CLARK HALL

**Re: Construction Storm Water Inspection at Clark Hall / Franklin County  
Permit Number 4GC03239\*AG**

Figure 2: Perimeter silt fence expected for fill area adjacent to Hamilton Road

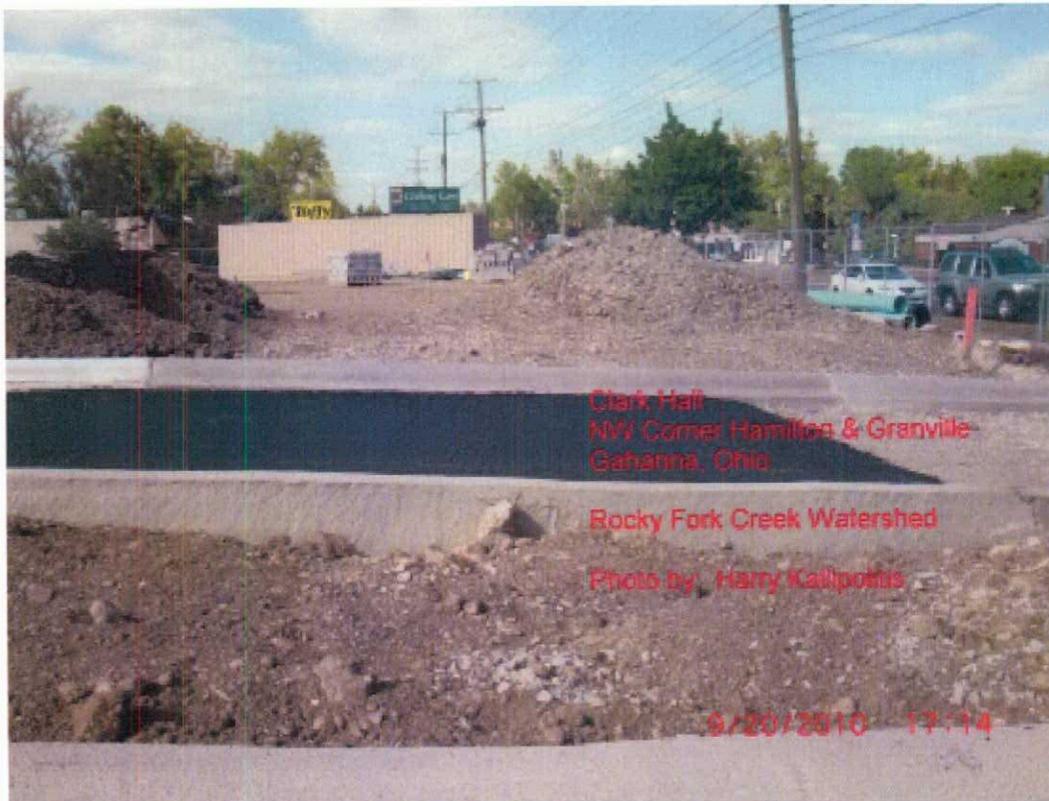
- Additional silt fence is required around the fill area directly adjacent to Hamilton Road entrance or demonstrate an approvable alternative (see figure 1).
